Municipal Planning & Design Review Commission
Regular Meeting Agenda
Thursday, August 19, 2021, 5:30 PM
City Hall, Lakeland, Tennessee 38002

Subject: Action on approval of a Site Plan at 3469 Lake District Drive N – Lake District Outparcel 6.

We are pleased to submit the following responses to the staff comments regarding Lot 6 of the Lake District. The original staff comment is shown, followed by our response in green text.

PROJECT: SHADRACHS
LIGHTING CALCULATION

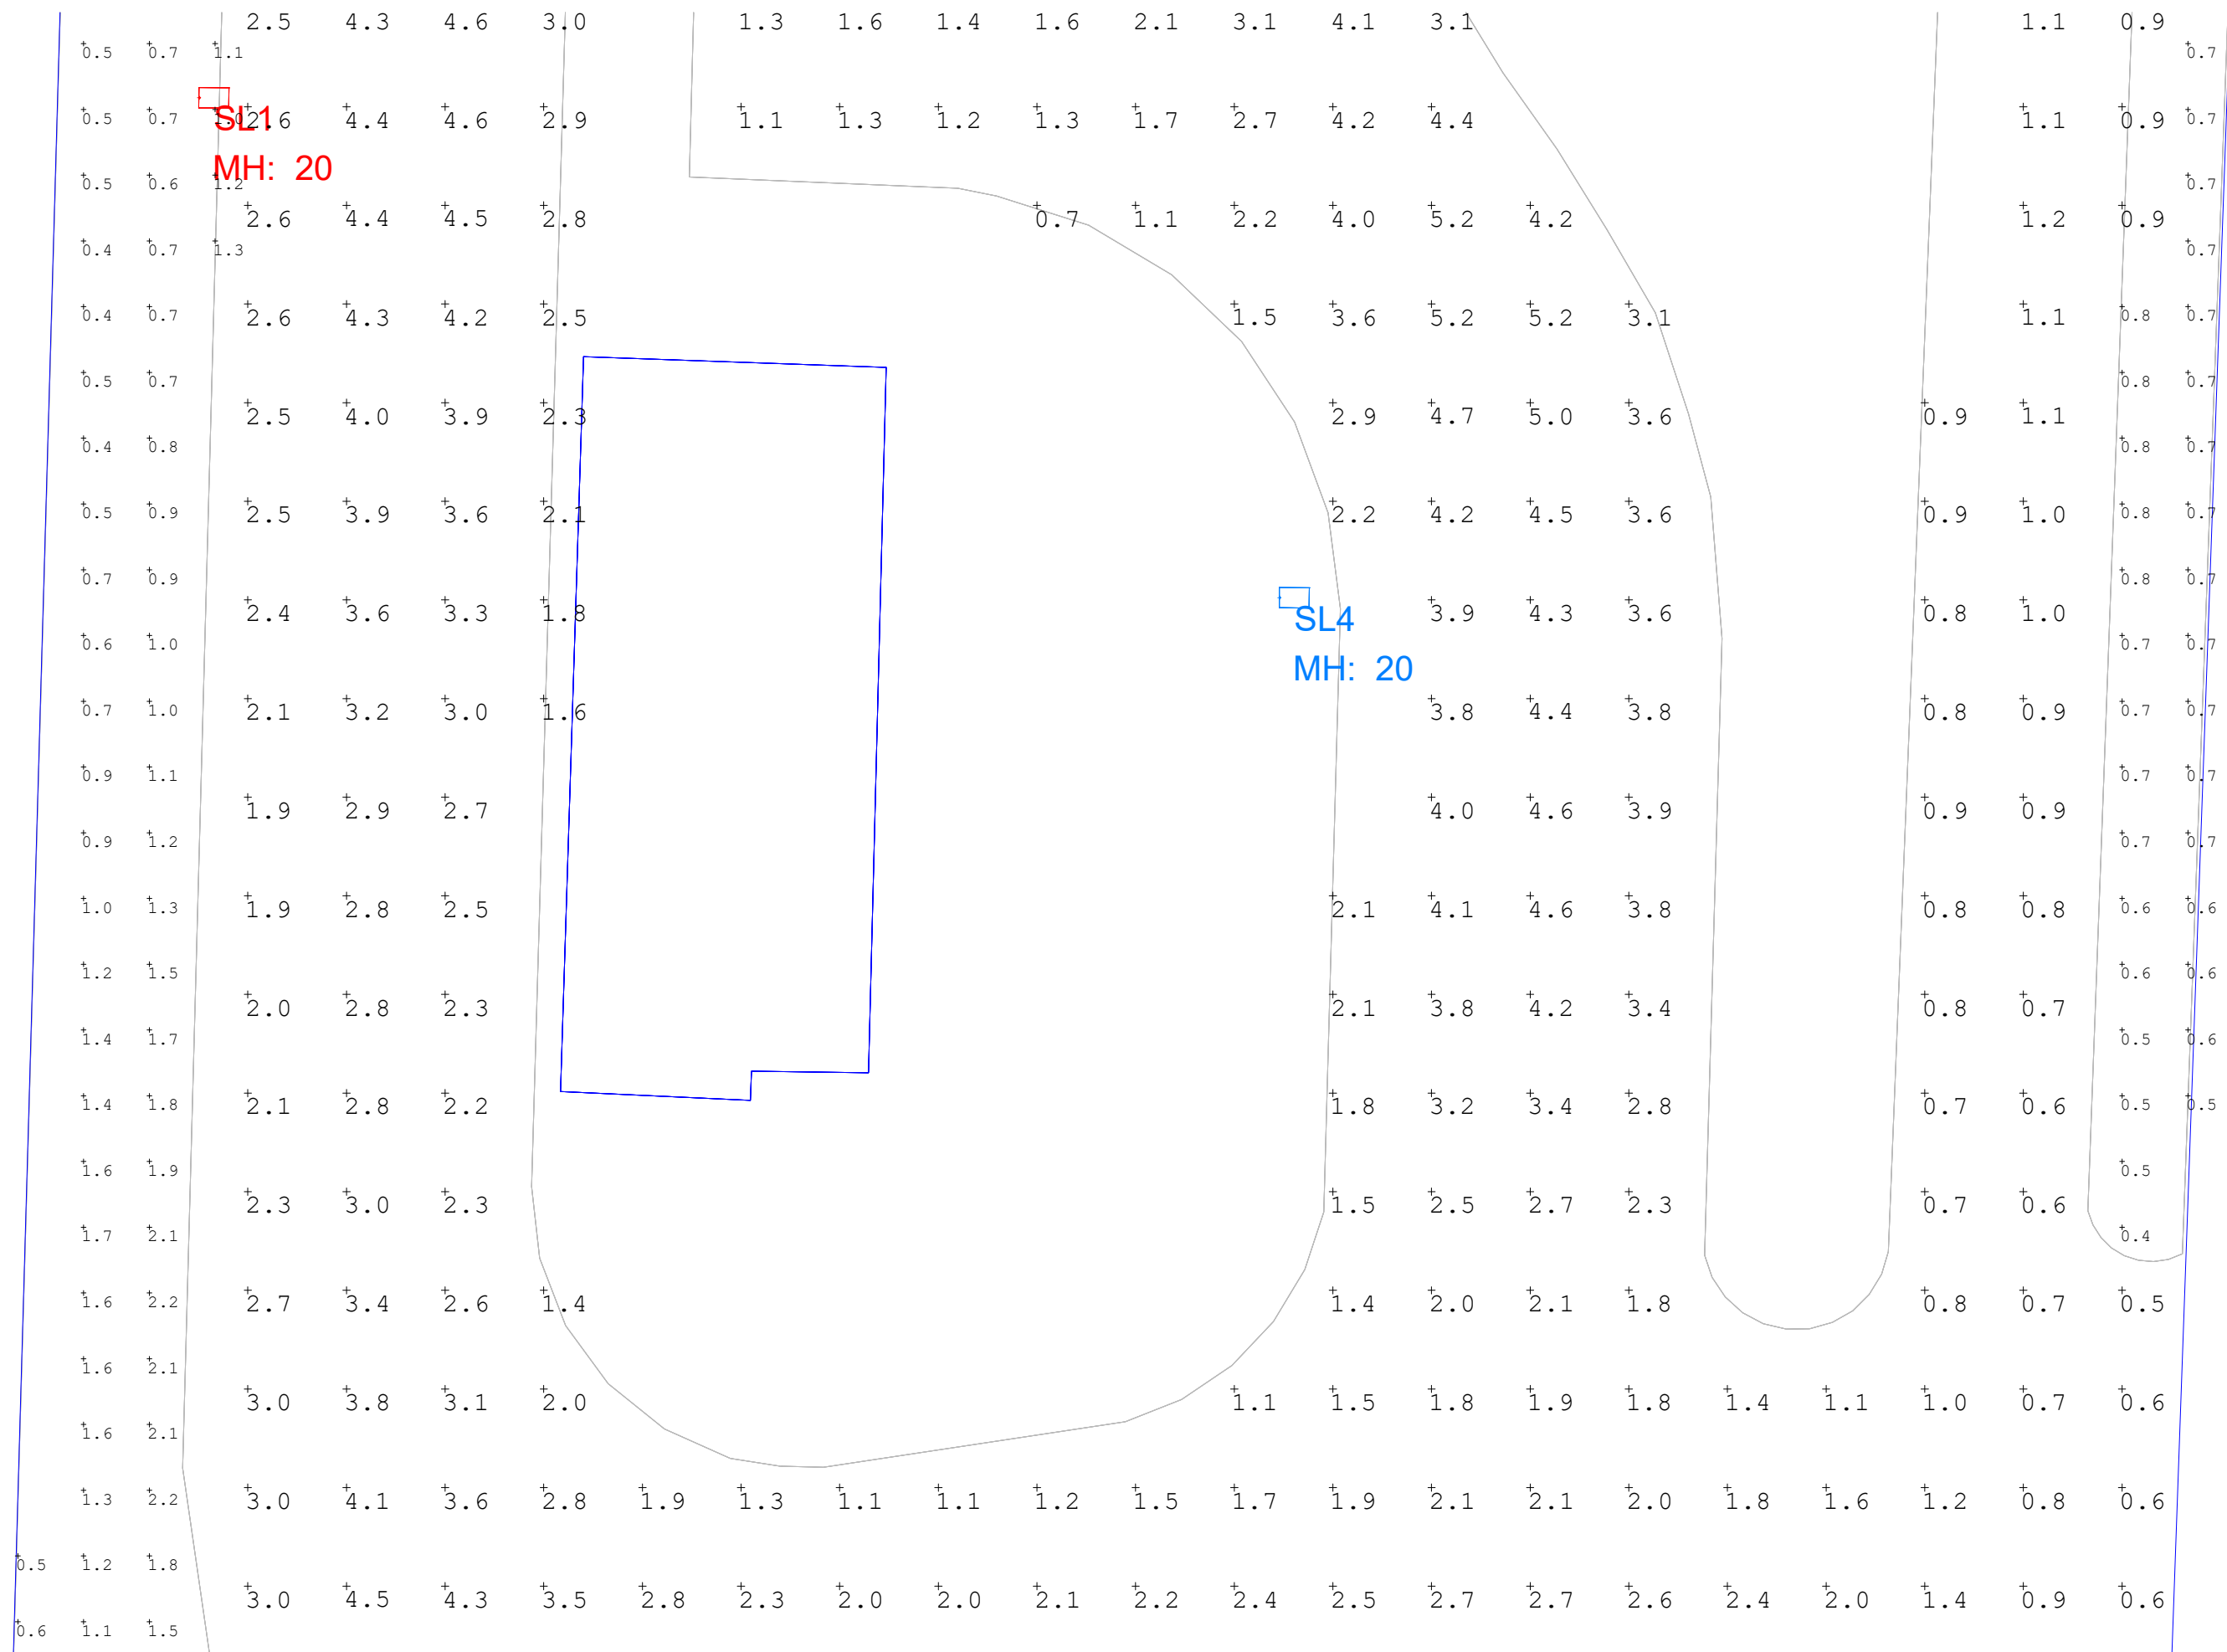
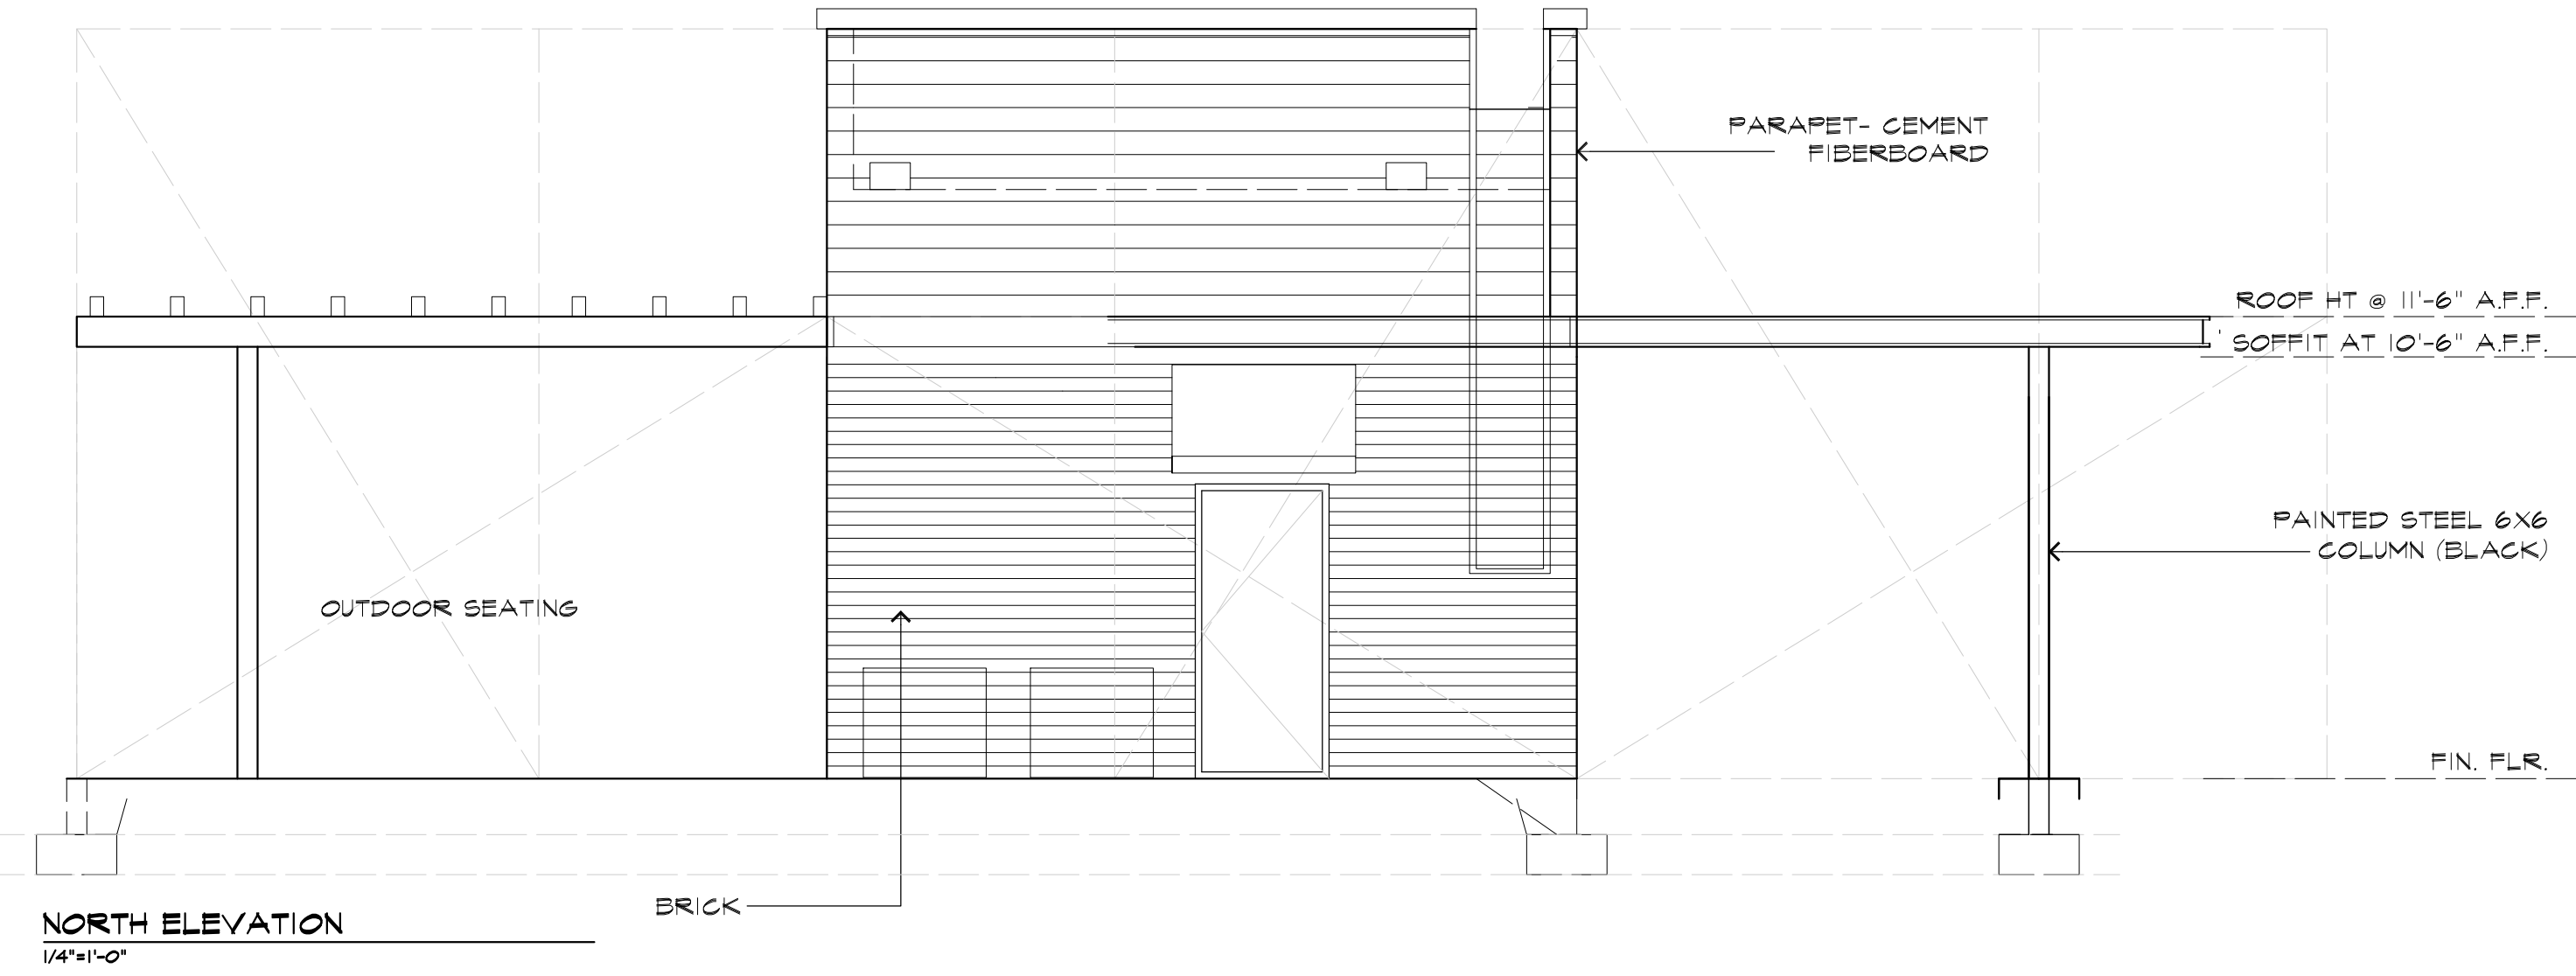
- The site lighting plan that was submitted last month includes several areas that exceed the 1 foot-candle requirement at the property line.
- The foot-candle reading at the property line is as high as 6.4 along the eastern edge and 5.8 along the western edge.
